A G E N D A

Architectural Review Board

May 26, 2020 – 5:30 p.m.

LOAN OR MORTGAGE SURVEY

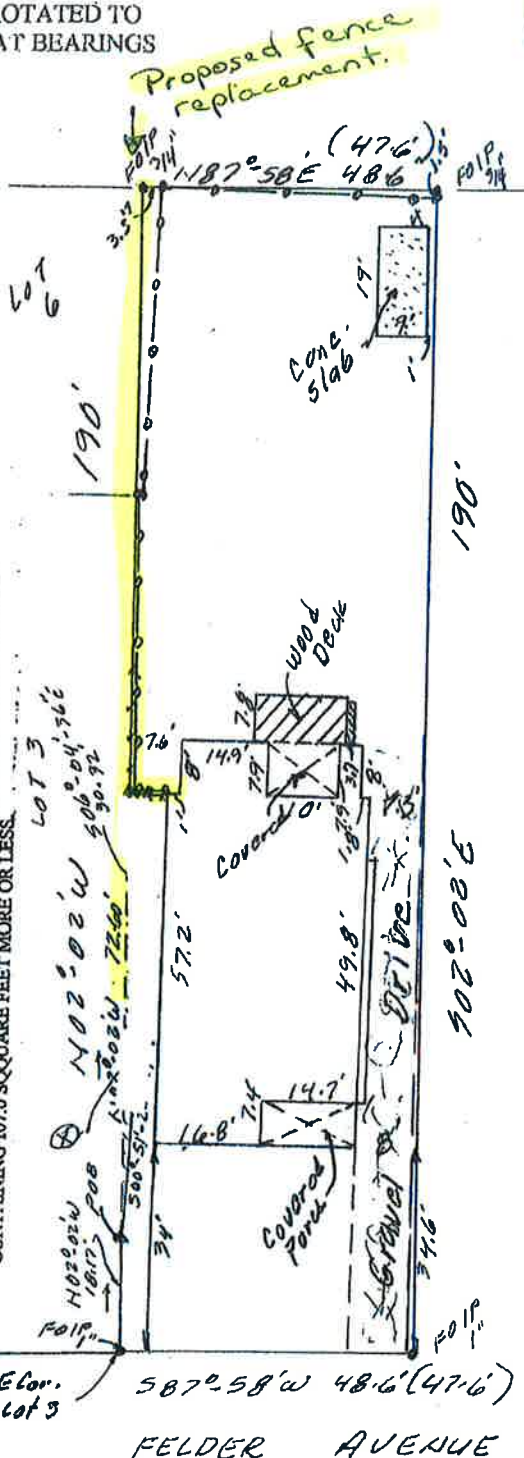
- The Board has routinely approved rear yard privacy fences.
- The Board has sometimes balked at the horizontal installation of fences, but has approved them. Privacy fences and decks are not historic features but are also routinely approved. The section of fence facing the street will be minimally visible.
- Guidelines suggest 6' privacy fences, 7' is permitted without a variance under the Zoning regulations. The Board has approved taller fences when circumstances warranted it.

3C

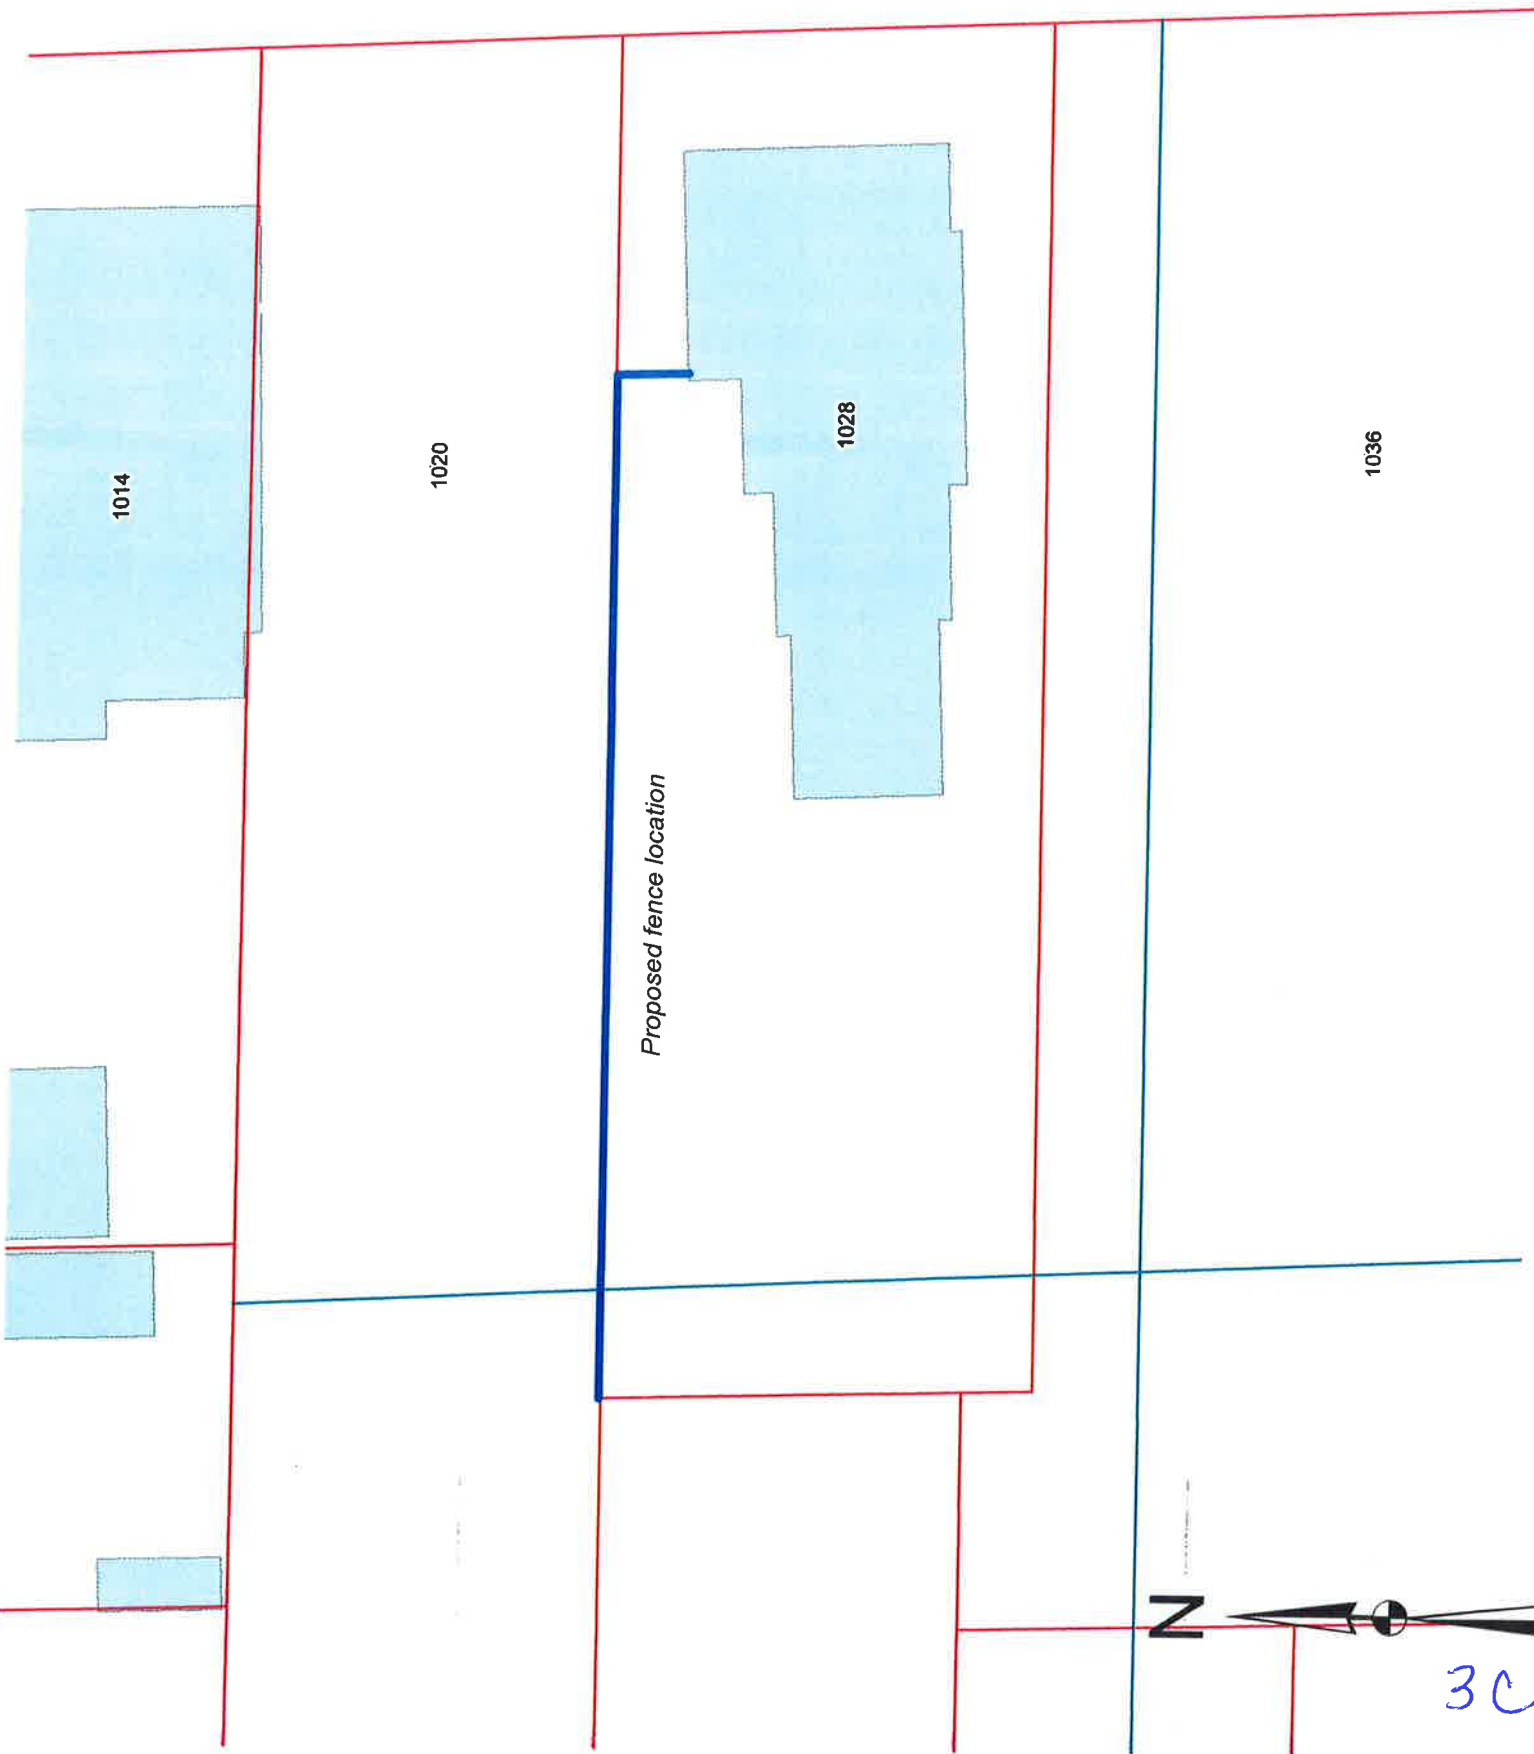
- The Board has routinely approved rear yard privacy fences.
- The north property line of this address marks the north boundary of the Garden District.

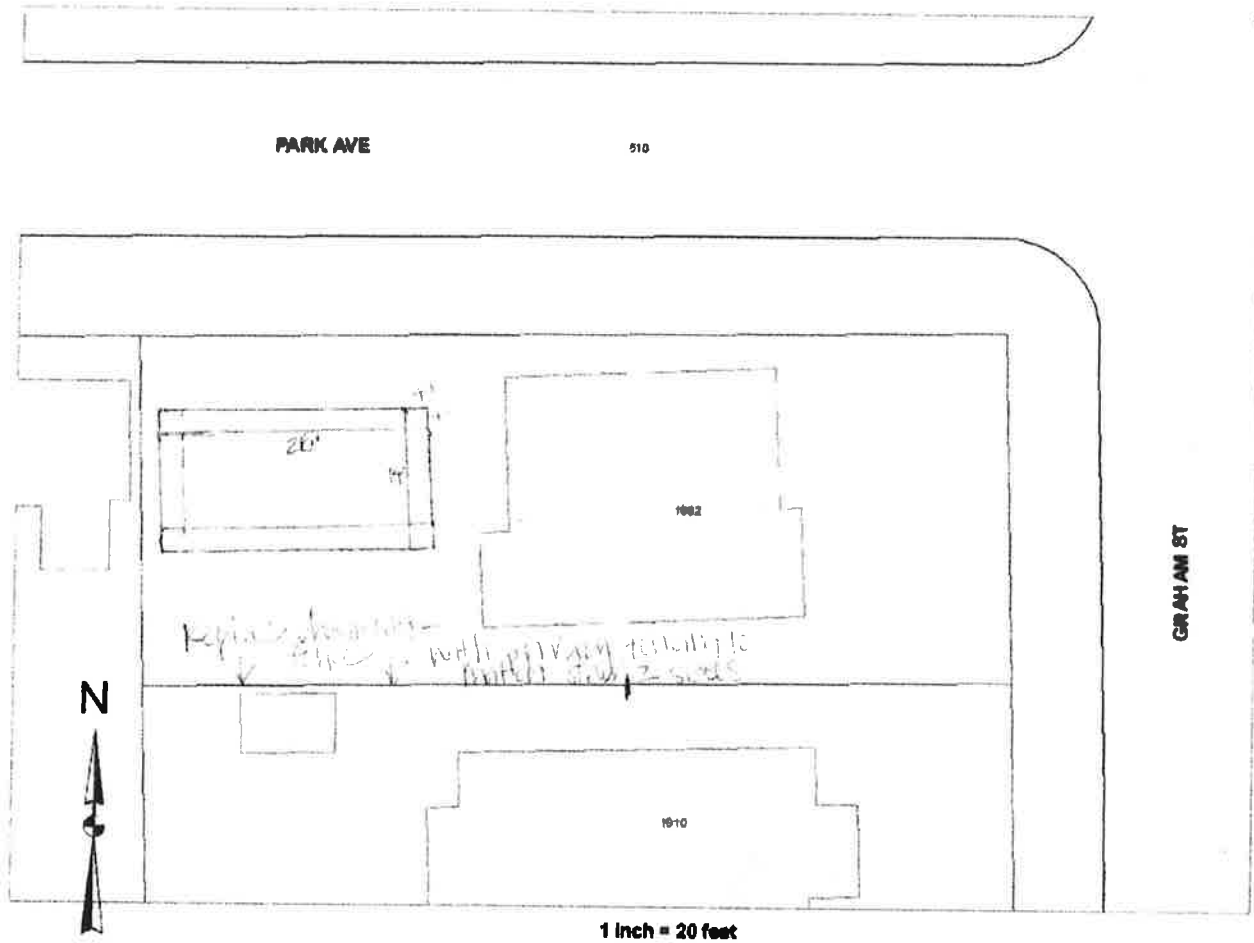
- The Board has routinely approved pools when they do not interfere with healthy, mature canopy trees.
- Urban Forestry does not believe any trees will be adversely affected.

1247 Felder Avenue

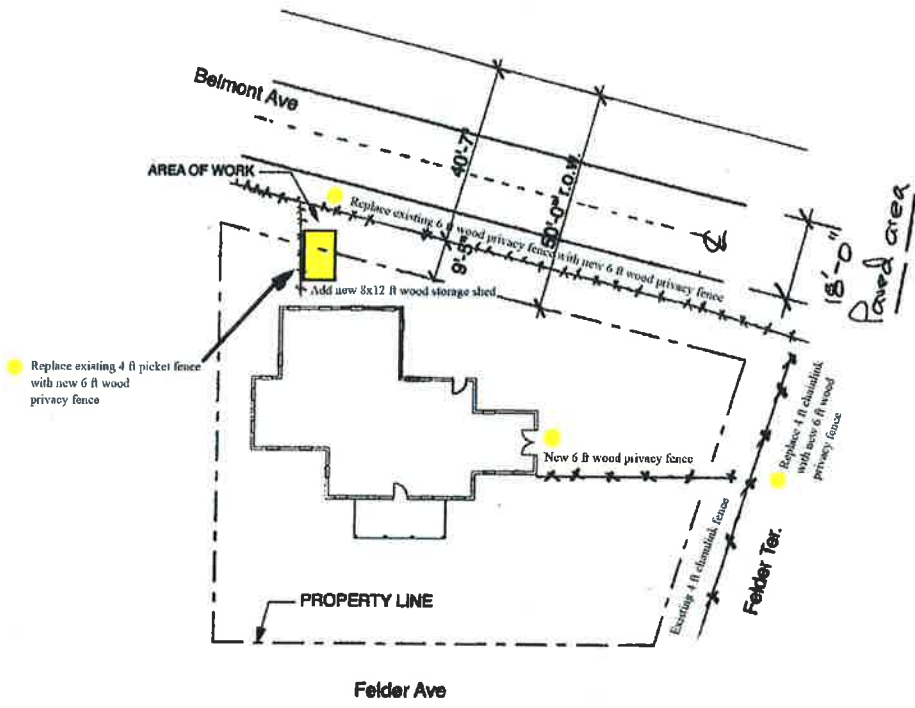
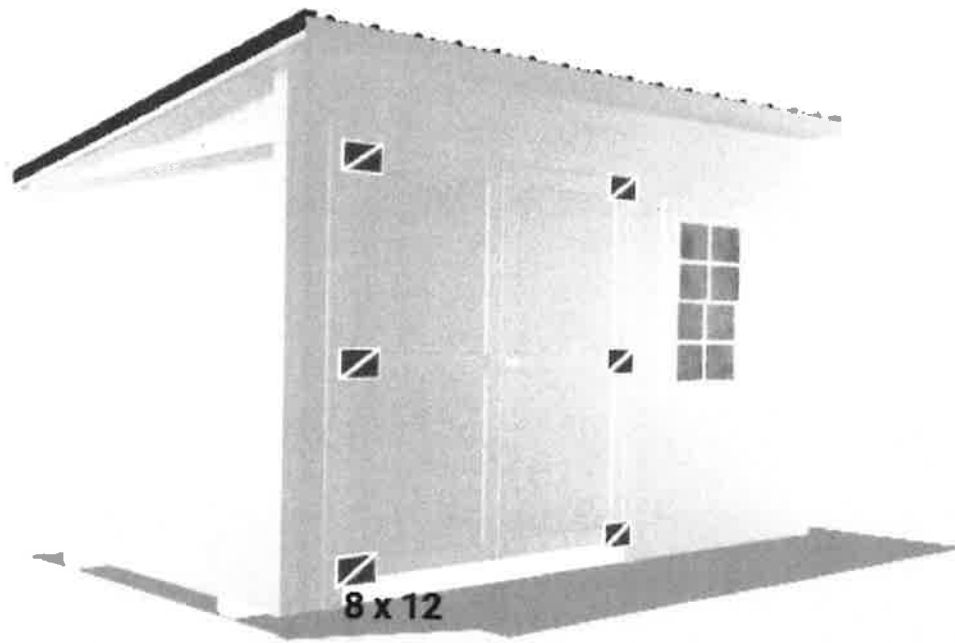
- This is an unusual lot with streets on 3 sides. The fence replacement also requires a license agreement with the city because it will encroach on the right of way. There had been a previous agreement in place, but it expired. The fence may need to cut the corner to allow a clear line of sight at Belmont and Felder Terrace, if the Board approves the fence it needs to be contingent upon receiving a license from the City and allow for the line of sight adjustment.
- The location of the shed is in the same location of a previously approved carport presented by a previous owner that was never built. If this property was already fenced in, the shed would be concealed and would have met the parameters for an expedited review because of its size and materials.
